AR-07-0401

Southern Nuclear Operating Company
Vogtle Early Site Permit Application
Response to Requests for Additional Information Letter No. 3

Response to February 16, 2007 RAI Letter No. 3

Figure 2.1-15 10 to 50-Mile Resident Population Distribution 2070

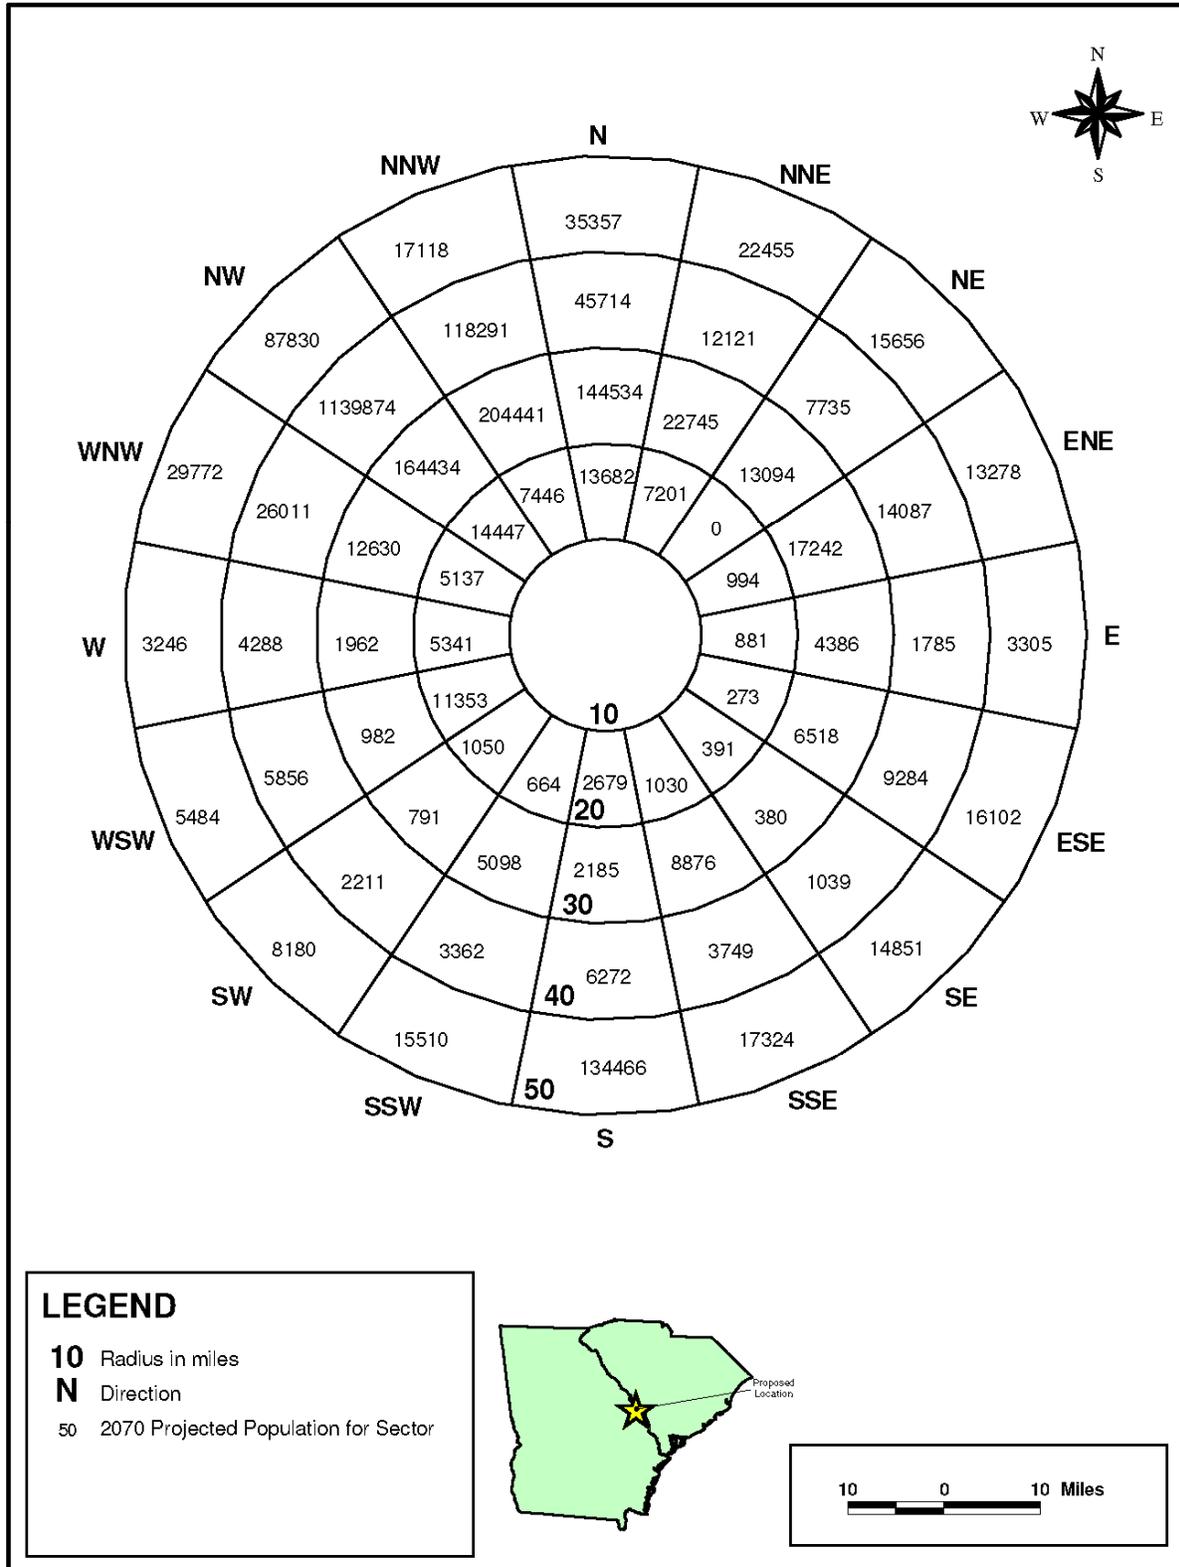
2.1.3-2 In Section 2.1.3, Figures 2.1-10 through 2.1-15 contain population distributions from 10-50 miles (population within 10 miles is not included), but the figures are labeled as 50-mile Resident Population Distribution, thereby implying that the population distribution presented is from 0-50 miles. Please change the title of the figures to represent the 10-50 miles Resident Population Distribution.

The titles for Figures 2.1-10 through 2.1-15 have been revised to show them as 10 – 50 Mile Resident Population Distribution. These revised Figures are included in Enclosure 2.

Figure 2.1-17 Low Population Zone

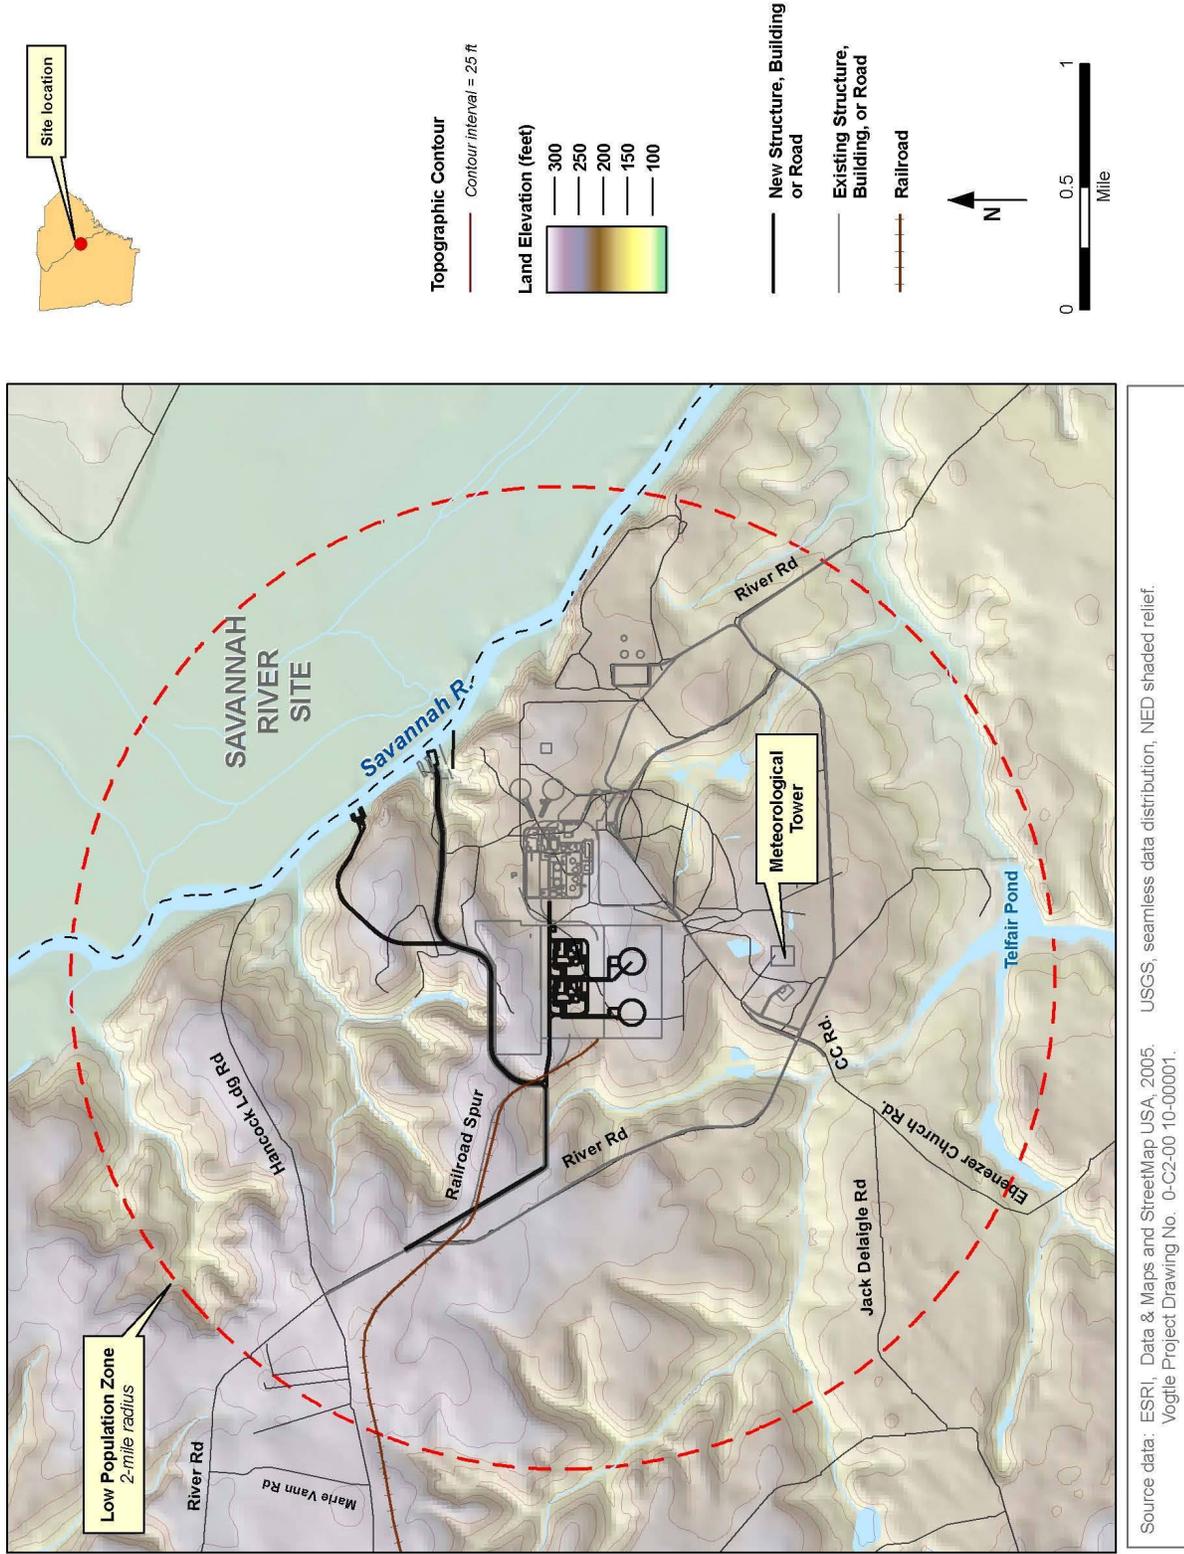
2.1.3-4 Provide a scaled map of the low population zone that includes topographic features, highways, railways, waterways, and any other transportation routes. Also, provide a scaled map of the location of all facilities within the LPZ.

A Figure 2.1-17 has been created to show the LPZ with topographic features that include highways, railways, waterways, and other transportation routes, as well as facilities within the LPZ. It is included in Enclosure 2.
